ADDENDUM NO. 01

TO SPECIFICATIONS AND DRAWINGS FOR

PHILLIPS PARK NORTH RESTROOM PAVILION

The contract documents for the above-mentioned project, dated February 5, 2026, are hereby amended by this Addendum, dated June 26, 2026, consisting of six (6) pages and two (2) full size sheets.

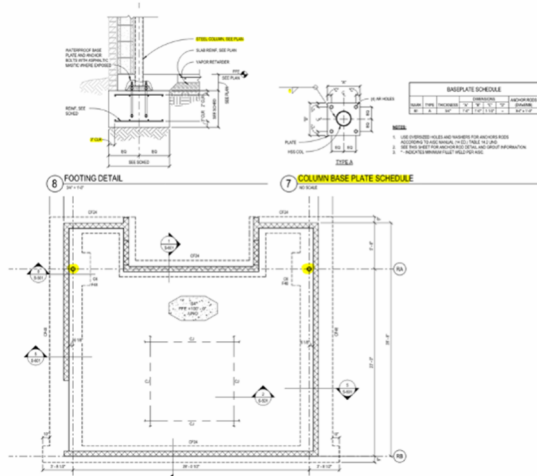
- Please clarify the size and length of columns according to what was found in the screenshot below

See Addendum 01 for column size. Length is determined by top of footing (el: 98'-8") up to beam bearing (el: 109'-7")
